**Lansing School District  
North Elementary Interior Renovations Bid Package 1**

**Addendum 01**

**January 13, 2026**

## FLOOR PLAN - DEMOLITION

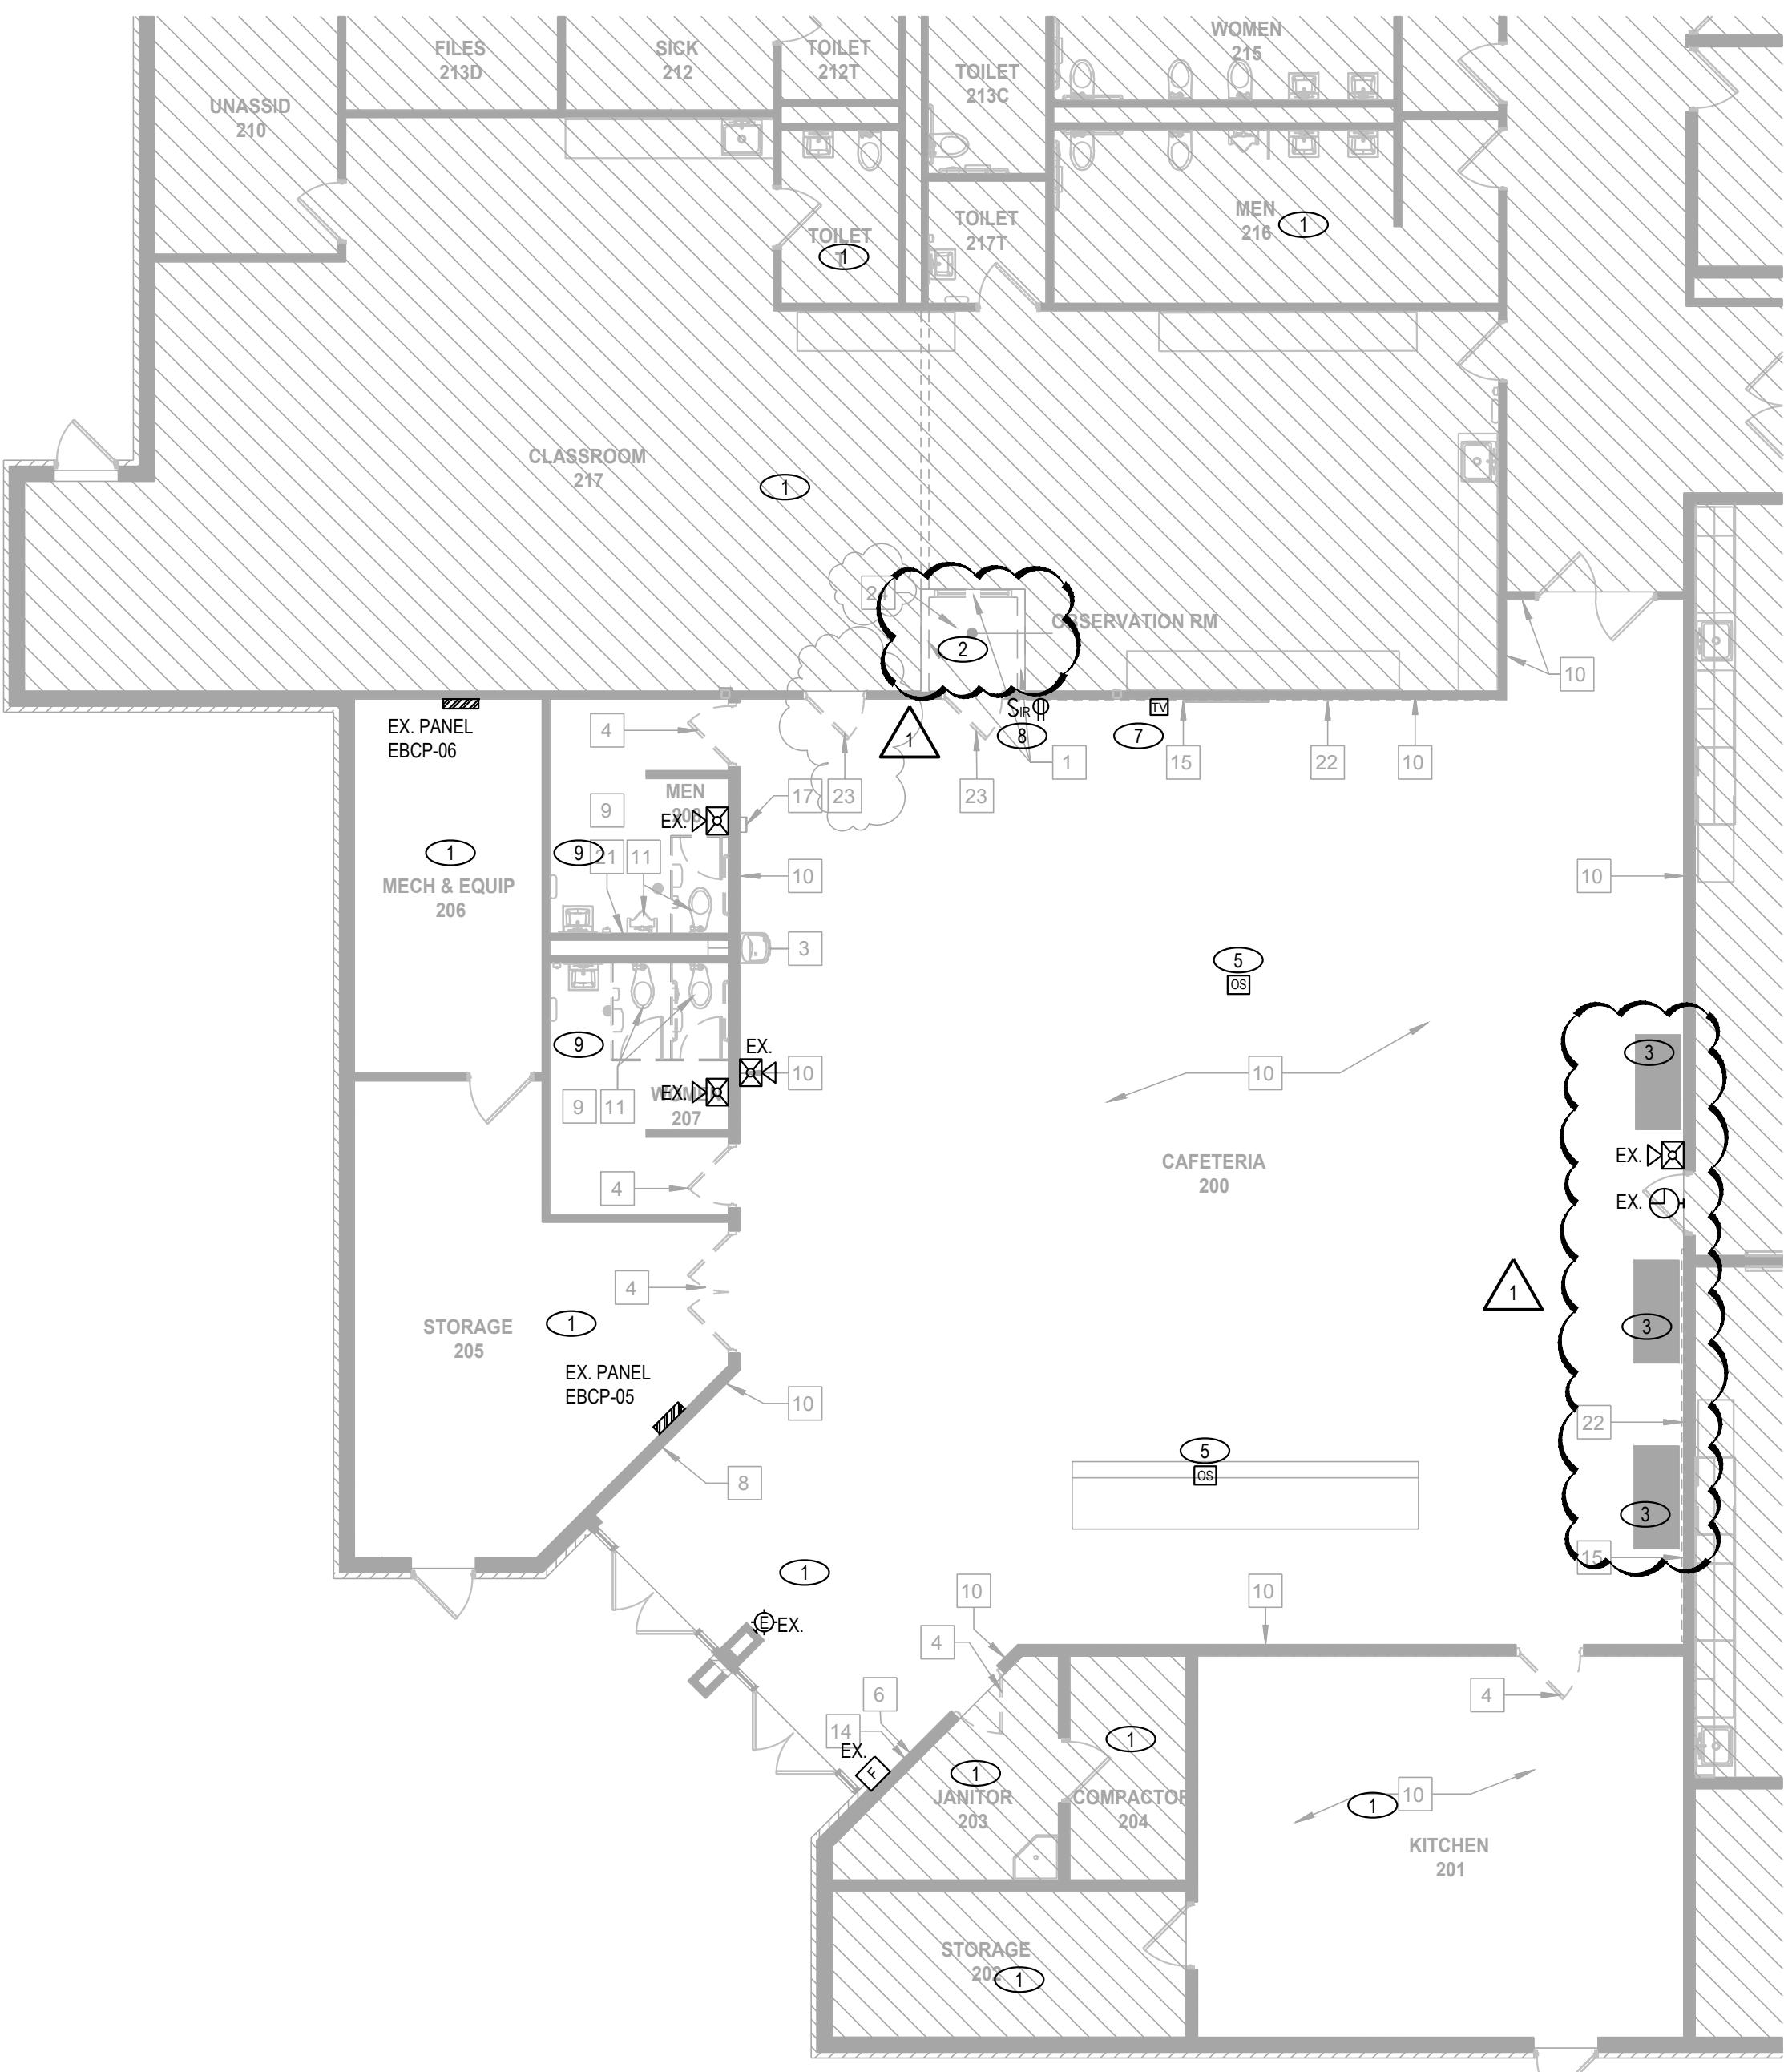
**Q:** Looking at the new out for bid documents compared to the most recent North project completed in 2021 by Centennial, there is already emergency lighting meeting current code within the cafeteria. This emergency lighting is fed from the emergency generator system and not battery packs. Please verify if new emergency lighting is required and where?

**Q:** I don't see in the plans any lighting controls in the drawings for the new bathroom lights. Will those be ceiling occupancy sensors, or wall switches? And if it is wall switches, what style of switch will be required?

**A:** See attached updated electrical drawings removing appropriate emergency lighting.

**A:** See attached updated electrical drawings for added lighting controls
